UNITED STATES
NUCLEAR REGULATORY COMMISSION
WASHINGTON, D. C. 20555

Subject: Issuance of Amendment No. 63 to Facility Operating License No. NPF-14 and Amendment No. 34 to Facility Operating License No. NPF-22 - Susquehanna Steam Electric Station, Units 1 and 2

AMENDMENT NO. 63 TO FACILITY OPERATING LICENSE NO. NPF-14 - SUSQUEHANNA, UNIT 1
AMENDMENT NO. 34 TO FACILITY OPERATING LICENSE NO. NPF-22 - SUSQUEHANNA, UNIT 2

Figure 6.2.1-1

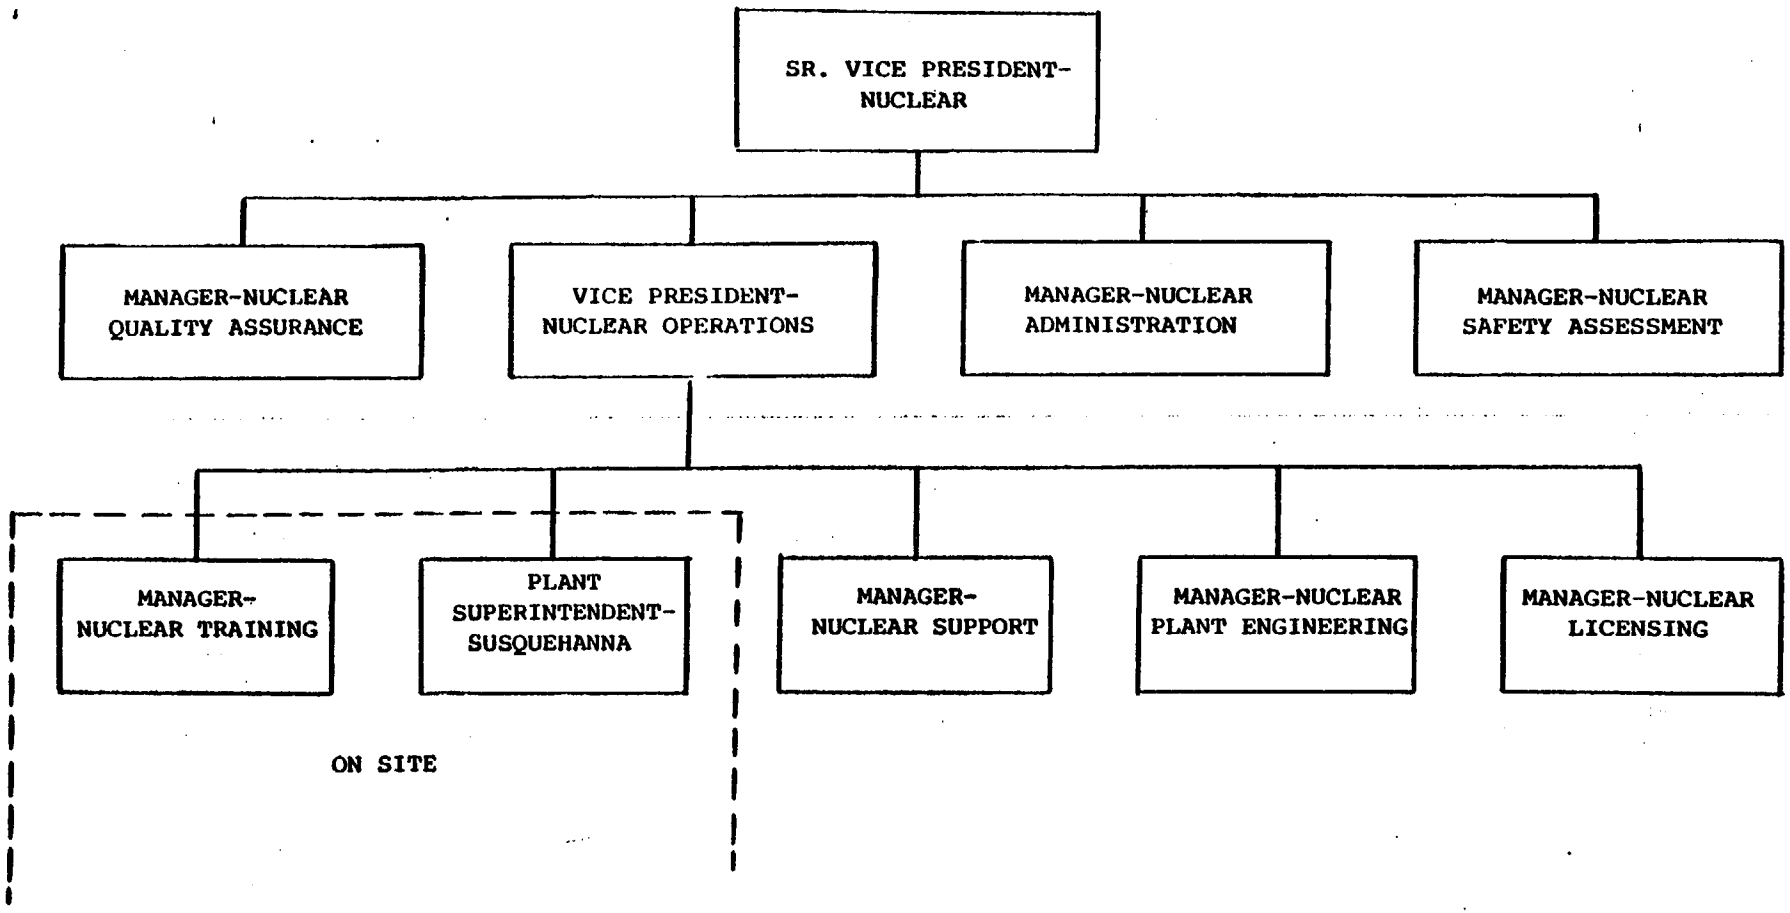
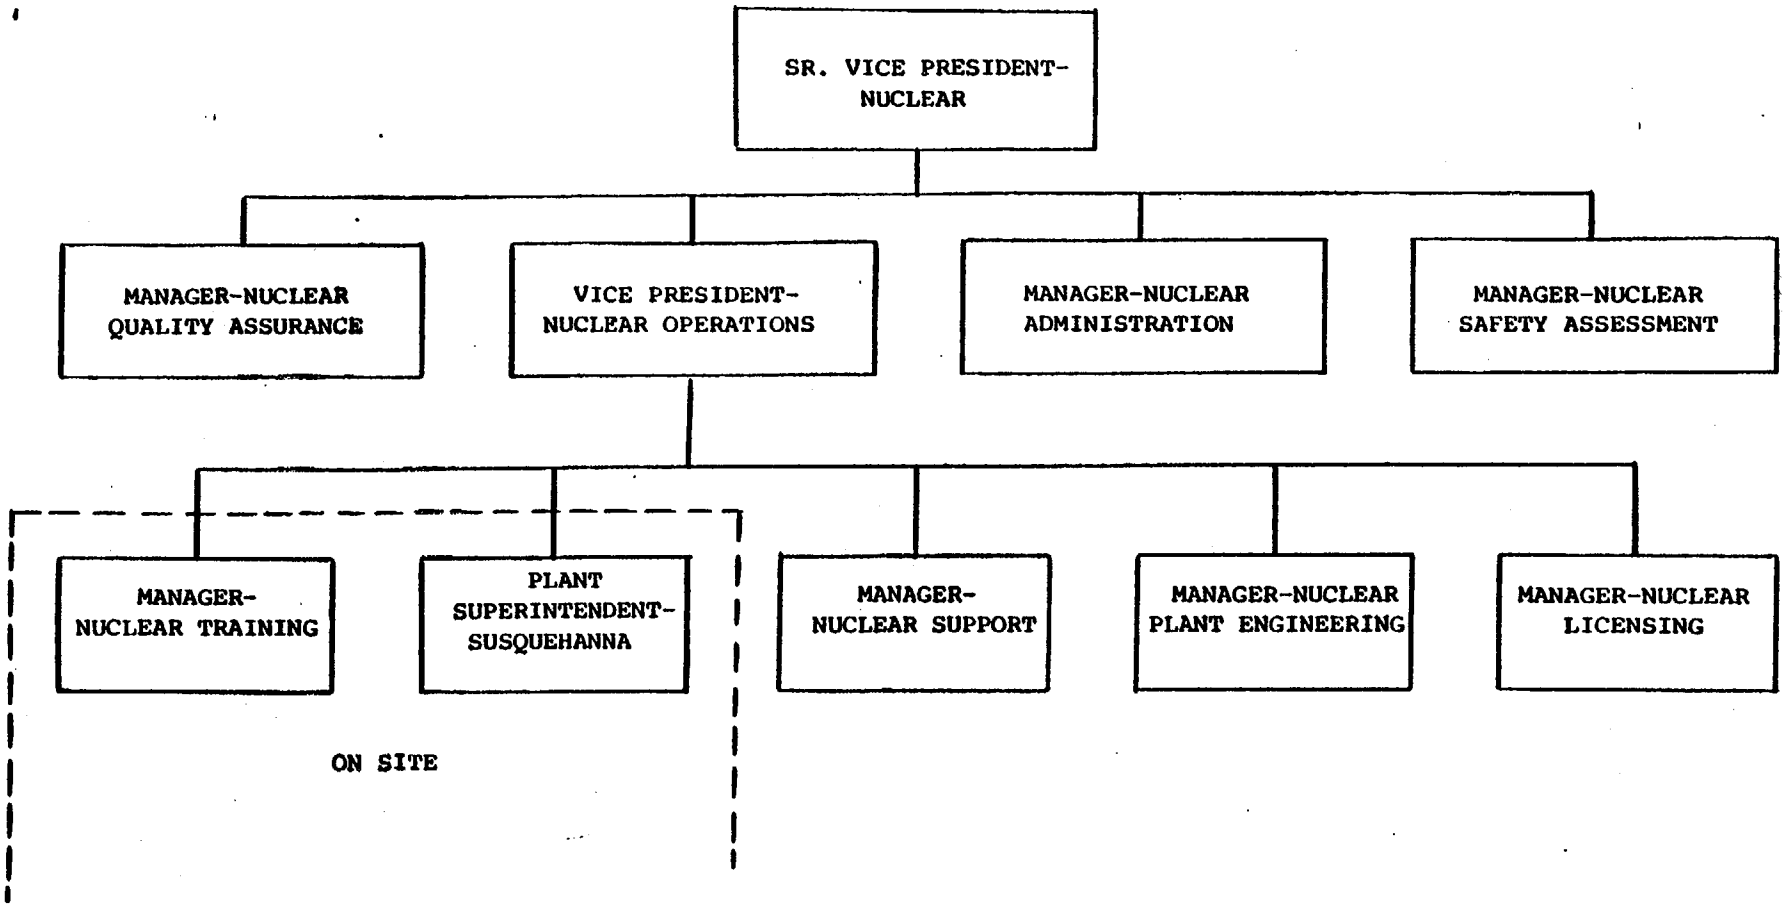
3. Deletion of Offsite Organization Position. Units 1 and 2: The deletion of the position "Vice President-Engineering and Construction-Nuclear" and the subsequent realignment as indicated in the change to Figure 6.2.1-1 for both units reflects PP&L's shift from construction to operation of the Susquehanna plant.

The personnel requirements of ANSI/ANS 3.1-1978 do not apply to this change, since the scope of these guidelines does not rise above the functional level of "Manager". The staff finds this change to be acceptable as it is consistent with Section 13.1.1 of the Standard Review Plan.
